Well Name: RR ZANOTTI

Notice of Intent

Type of Action: Plug and Abandonment

CONDITIONS OF APPROVAL

Current WBD

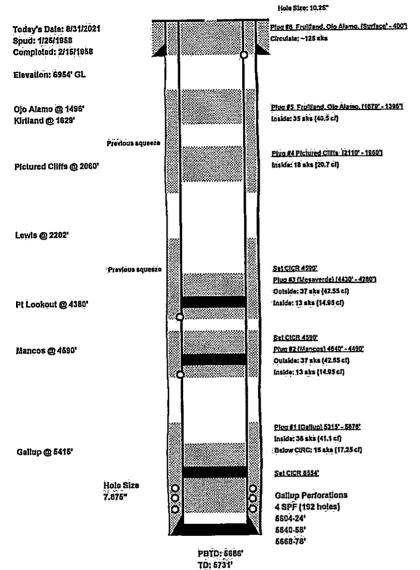
- BLM picks for the top of the Gallup, Fruitland, Kirtland, and Ojo Alamo formations vary from Operator submission.
- Adjust Plug #3 (Mesaverde) to cover the top of the Cliff House formation at 2890'.
- Add a plug (inside/outside if needed based on CBL) to cover the Chacra formation top at 2305'.
- Bring the top of Plug #4 up, or add a plug, to cover the Fruitland formation top at 1855'.
- The plugs proposed in the P&A procedure, with recommended changes, will adequately protect any freshwater sands in this well bore.
- Gallup perfs 5604' 5678'.

- 1. Plugging operations authorized are subject to the attached "General Requirements for Permanent Abandonment of Wells on Federal and Indian Lease."
- 2. Farmington Office is to be notified at least 24 hours before the plugging operations commence (505) 564-7750.
- 3. The following modifications to your plugging program are to be made:
 - a) Plug 3 (Mesa Verde): Adjust to cover the top of the Cliff House formation at 2890'.
 - b) Add a plug (inside/outside if needed based on CBL) to cover the Chacra formation top at 2305'.
 - c) Plug 4: Bring the top, or add a plug, to cover the Fruitland formation top at 1855'.
 - d) Bring the bottom of Plug 6 down to cover a minimum of 50 feet below the surface casing shoe at 394'.
